Addendum 002

San Ramon Fire Station 34 Remodel

Issued: November 9, 2021

40VM900003 - Wired Remote Controller (Programmable)

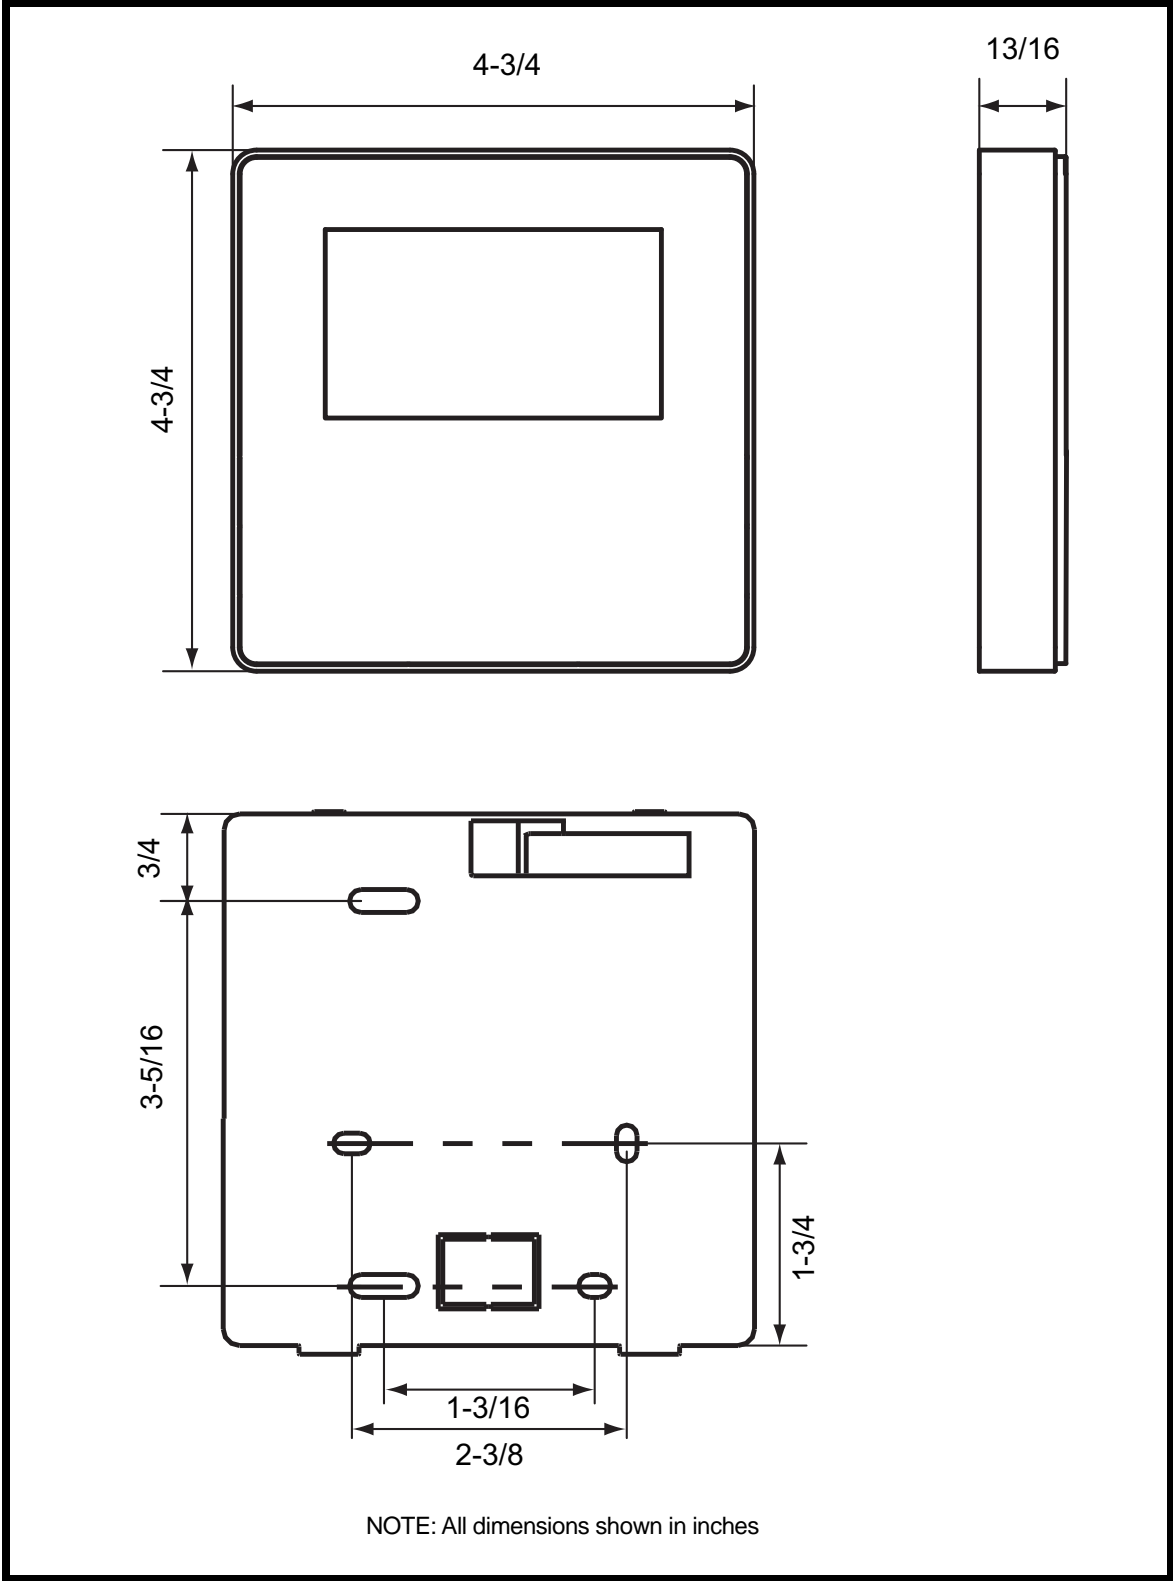
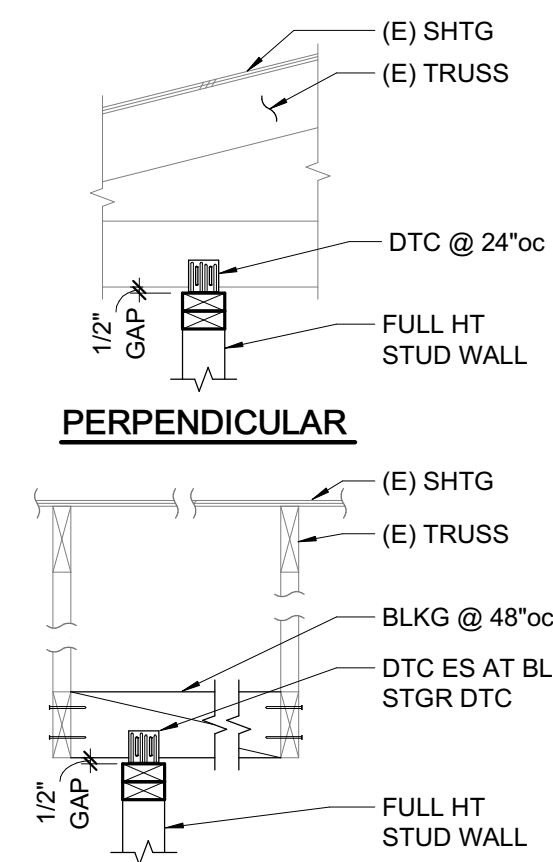
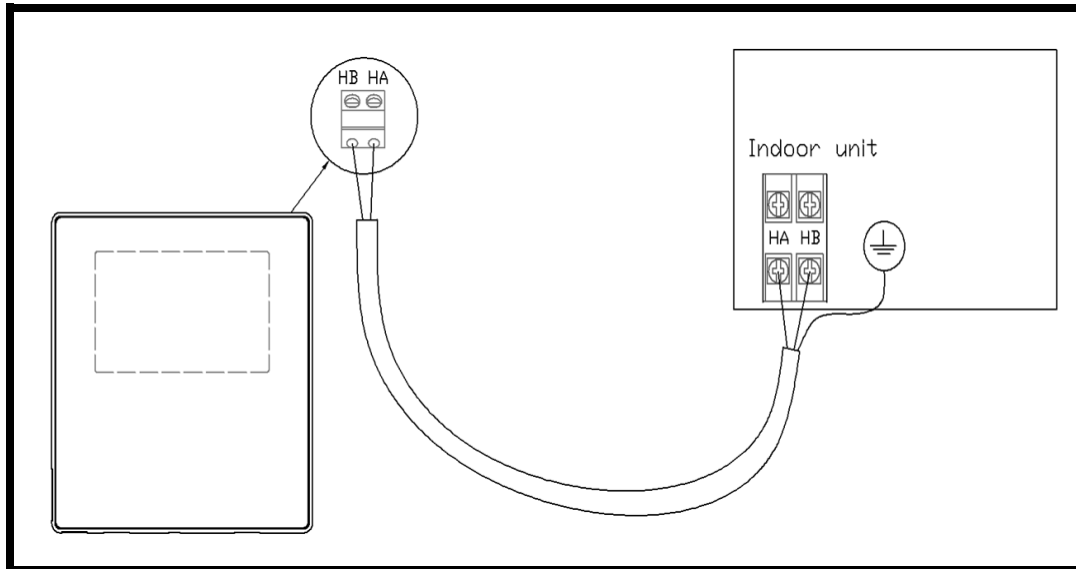
The VRF Sequence of Operations on sheet M4.1 is super blurry and isn't legible. Can you please provide a clear copy?

The blurry area refers to a controller. An enlarged cut sheet of that controller is included in the attachments.

14 NEW HOLDOWN AT EXISTING FOOTING
3/4" = 1'-0"

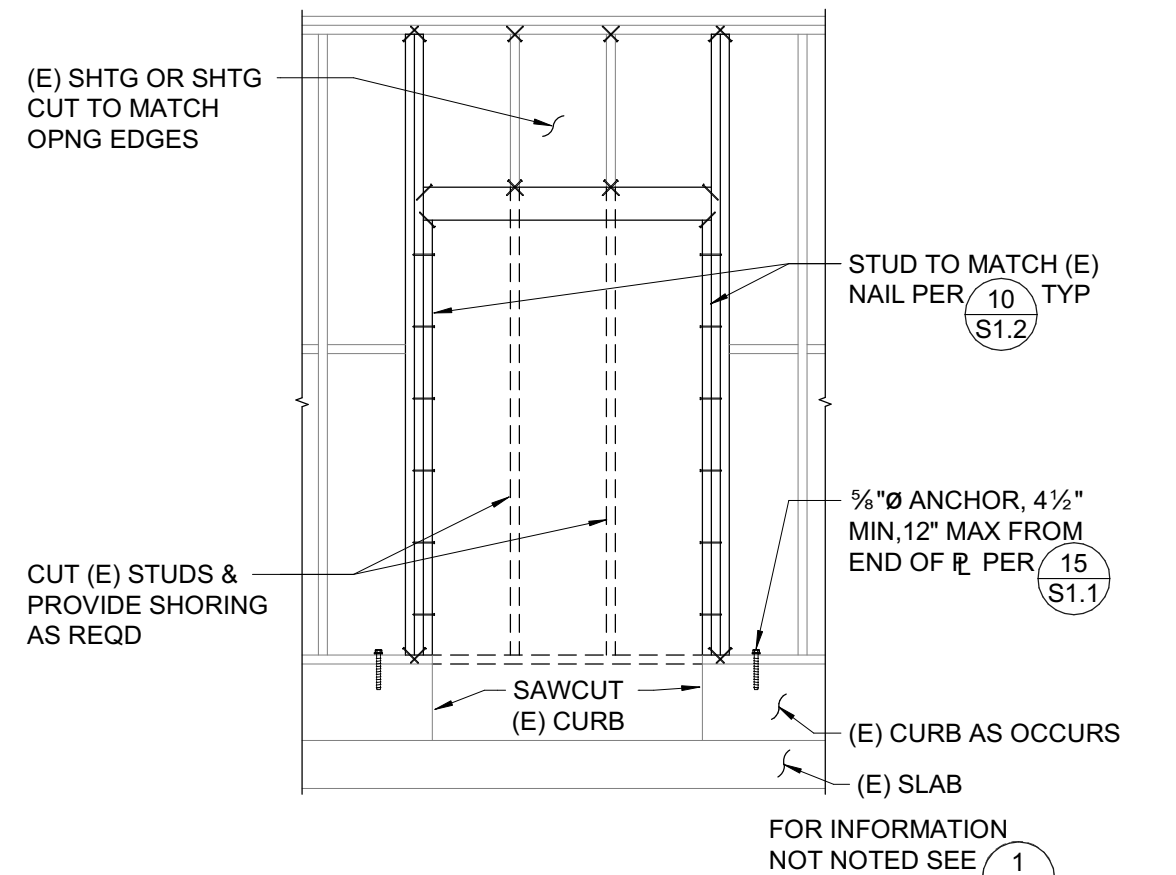
- a. Revise Drawing Sheet S1.5
 - i. Revised detail 14 New Hold Down at Existing Footing
- b. Revise Drawing Sheet S2.1
 - i. Revised foundation plan to show revised hold down size at column line 5 near column line D.5
- c. Revise Drawing Sheet S3.2
 - i. Revised elevation 1 to show added strap at gridline 5
- d. Addition of Drawing Sheet A1.1a
 - i. New drawing sheet showing temporary site plan for App Bay and Modular Living Quarters
